MDS SELF-STORAGE

RE: Mesa Del Sol Self Storage 5500 Turing Dr. SE Grading and Drainage Plan Engineer's Stamp Date: 5/7/2025 Hydrology File: R16DA1004

Re: Mesa Del Sol Self Storage 2322 Mesa del Sol SE Traffic Circulation Layout

MESA DEL SOL ARCHITECTURAL CONTROL COMMITTEE SITE DEVELOPMENT PLAN REVIEW

Principal Engineer, Hydrology

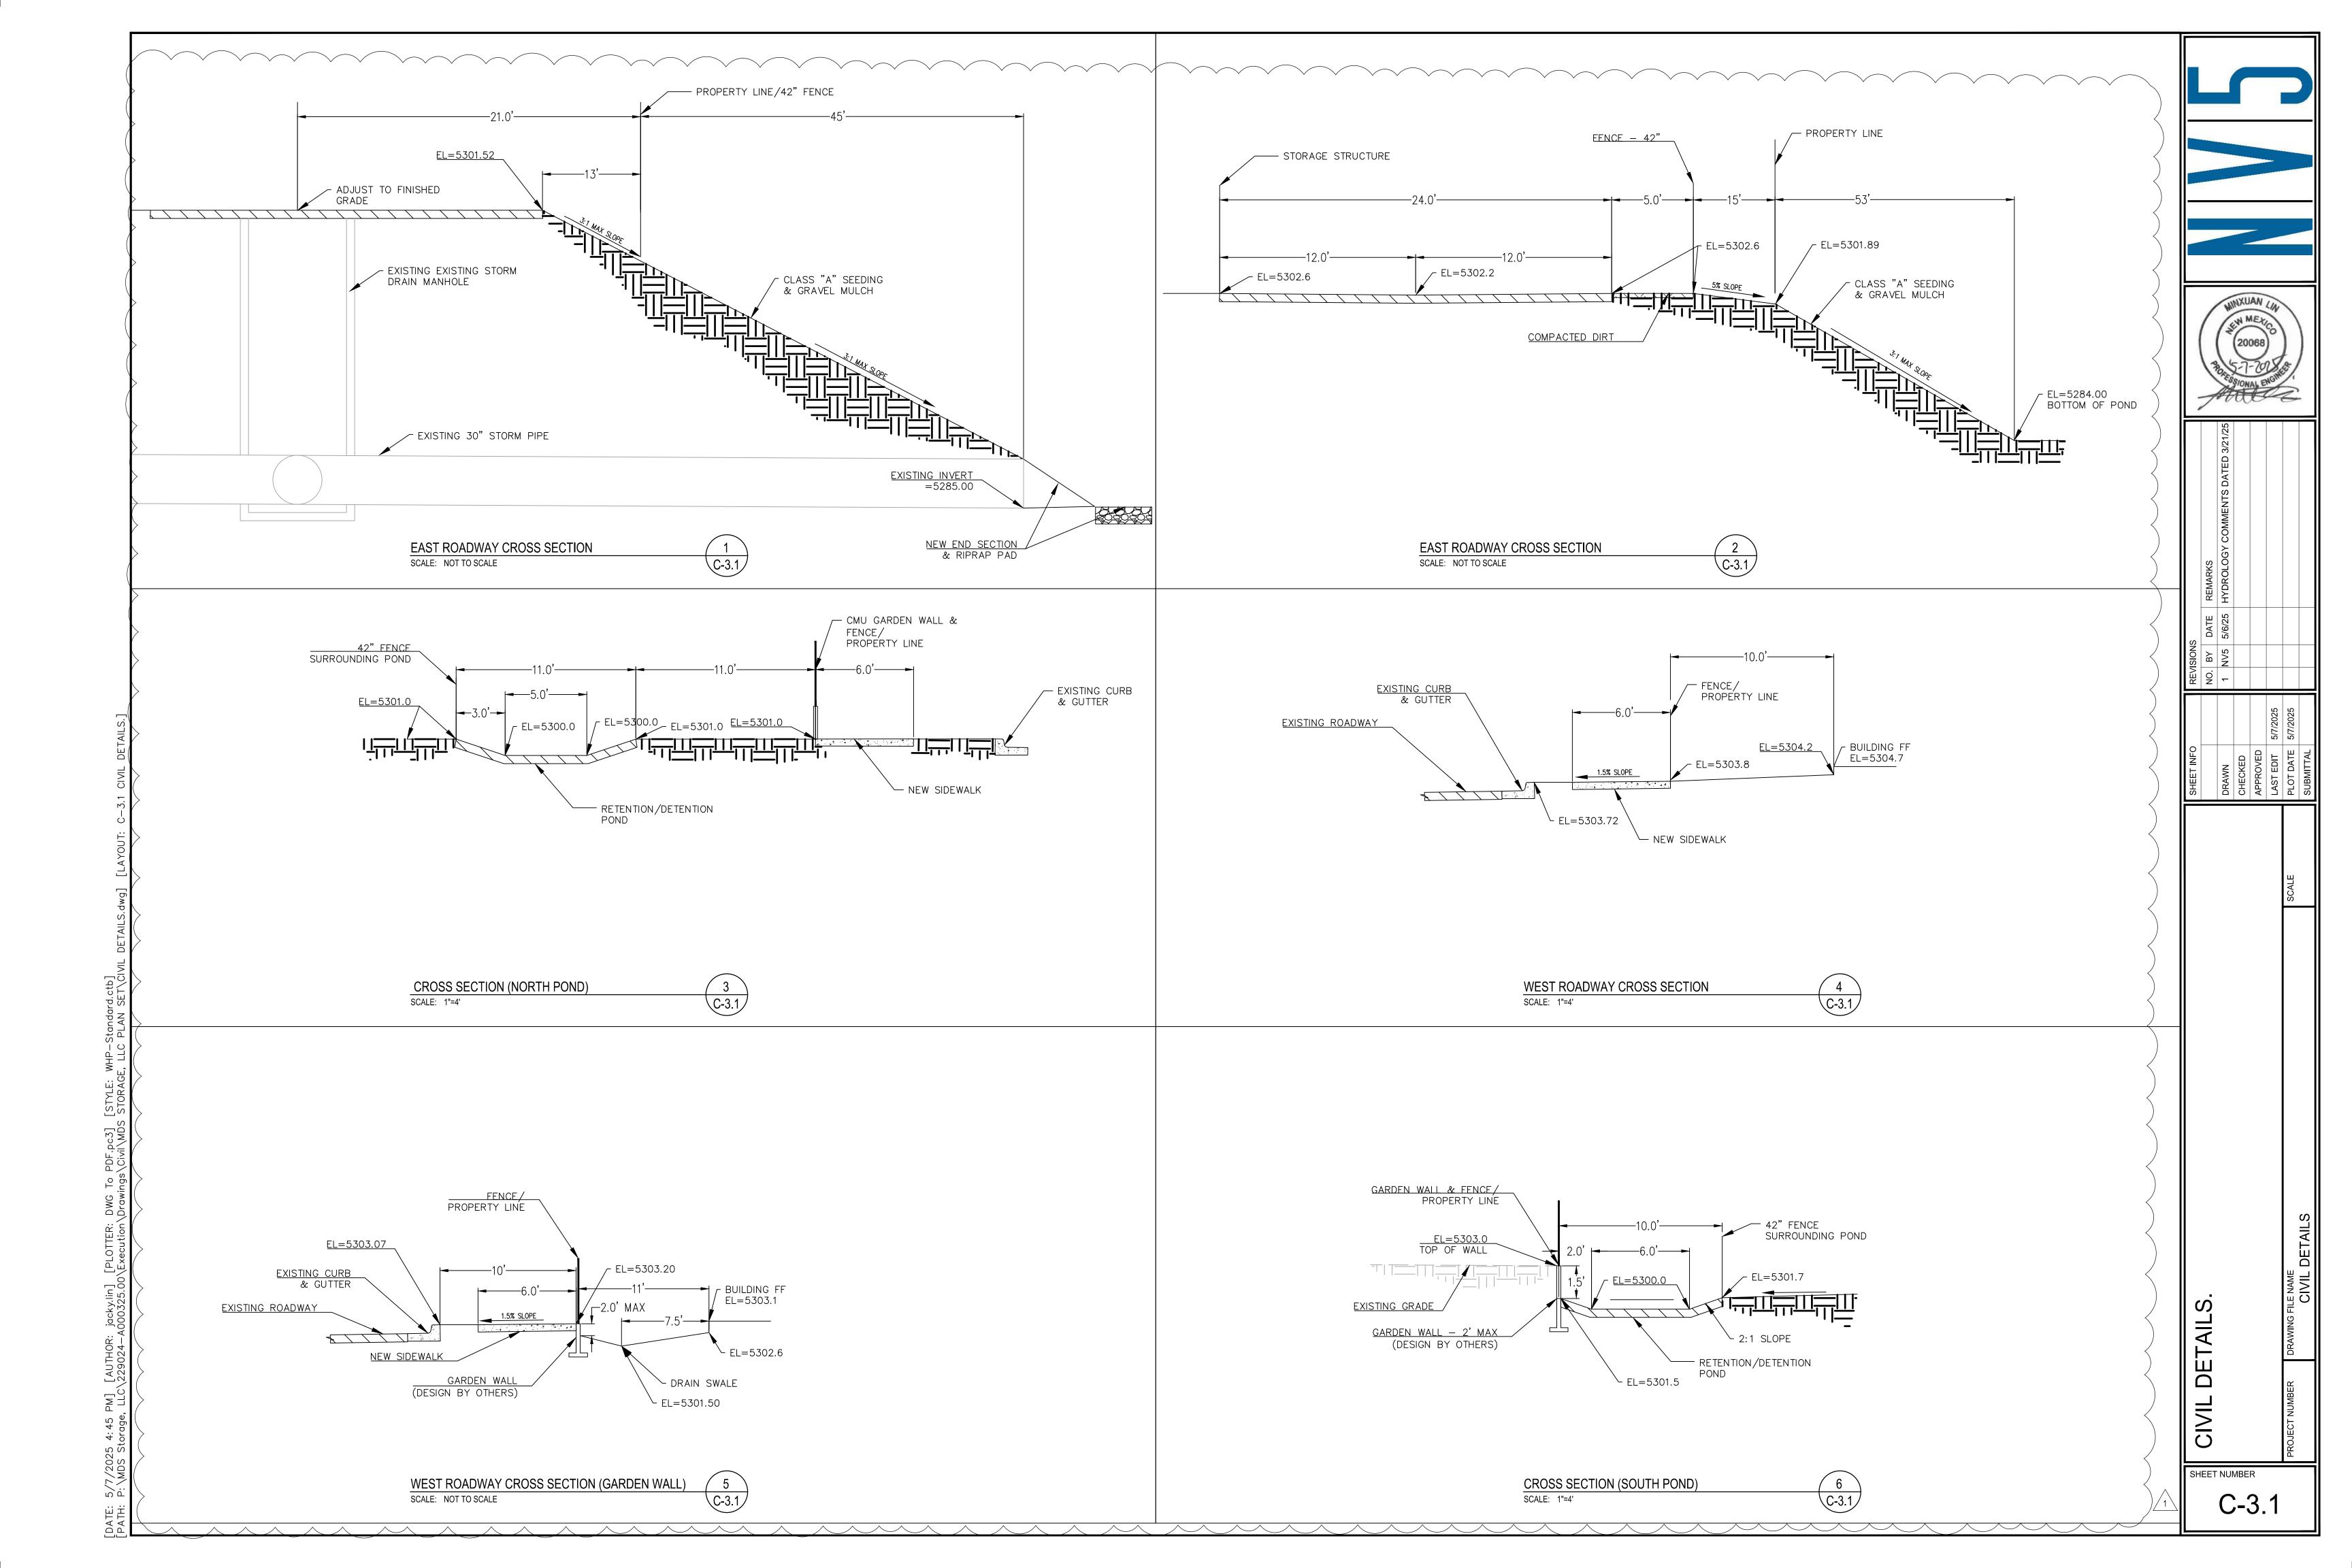
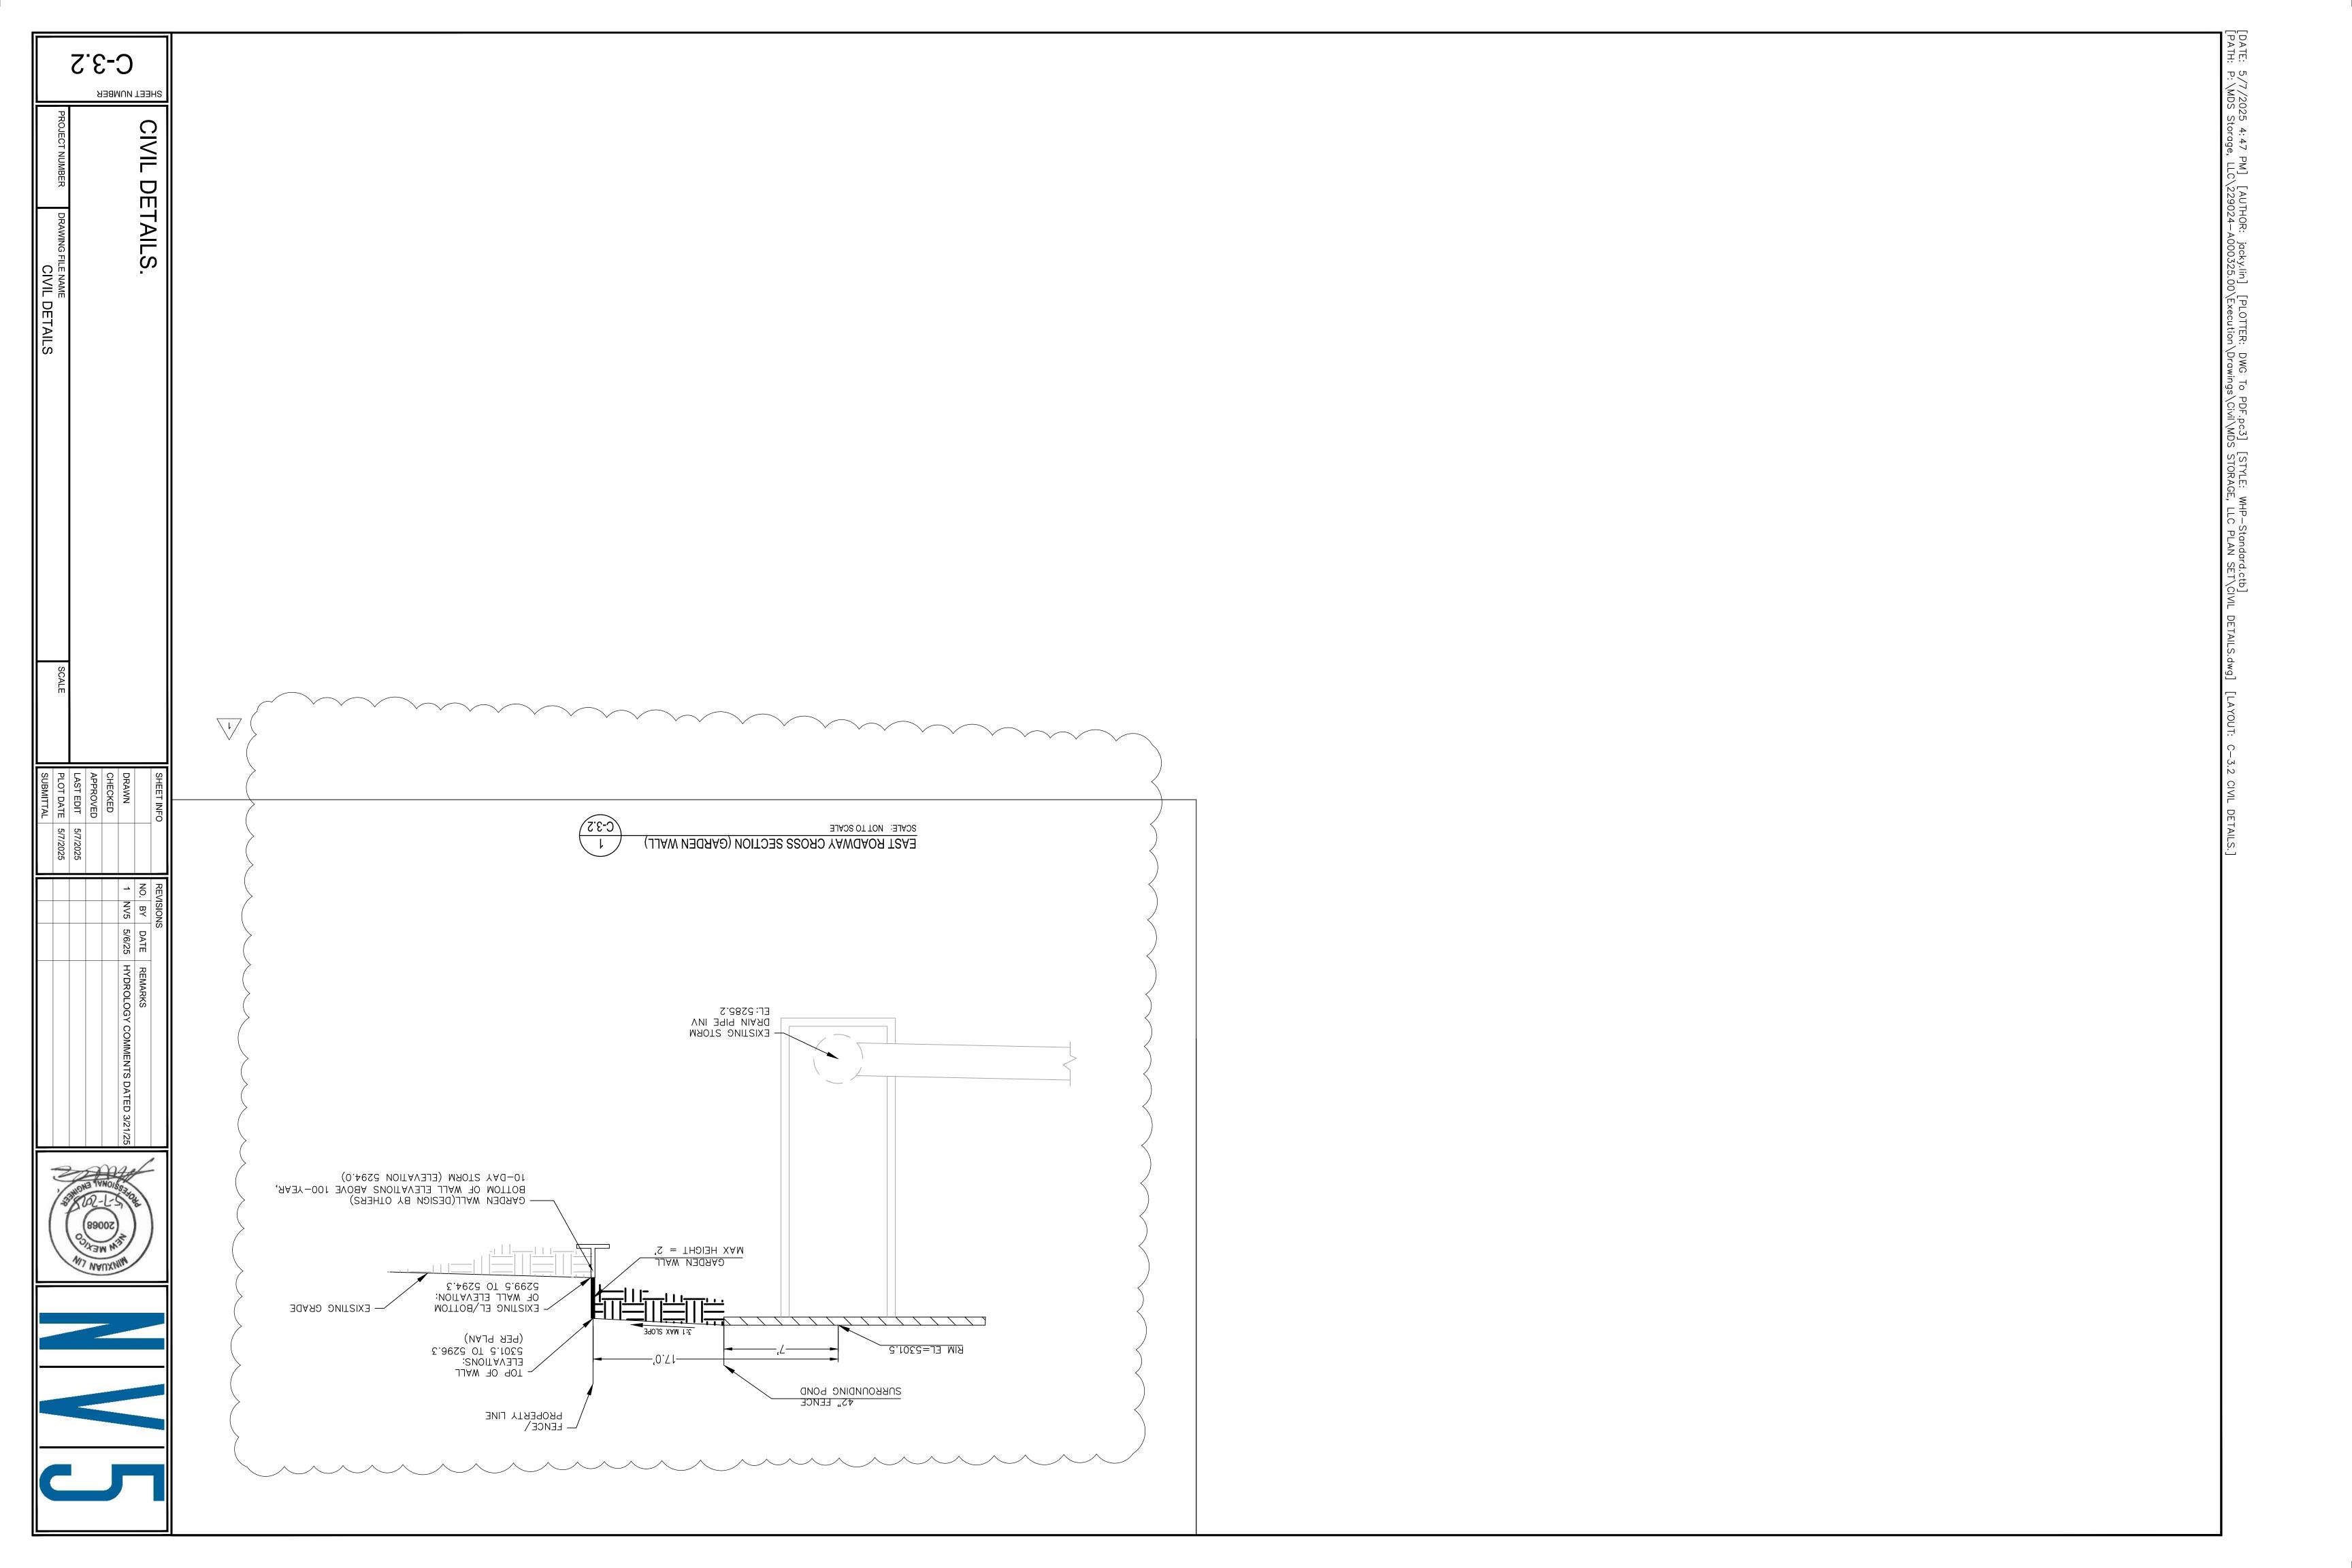
Based upon the information provided in your submittal received 5/7/2025, the Grading Plan is approved for Building Permit. Please attach a copy of this approved plan in the construction sets for Building Permit processing along with a copy of this letter.

1. Engineer's Certification, per the DPM Part 6-14 (F): *Engineer's Certification Checklist For Non-Subdivision* is required.

2. Please provide the executed paper Drainage Covenant (latest revision) printed on one-side only with Exhibit A and a check for \$25.00 made out to "Bernalillo County" for the stormwater quality pond per Article 6-15(C) of the DPM to Hydrology for review.
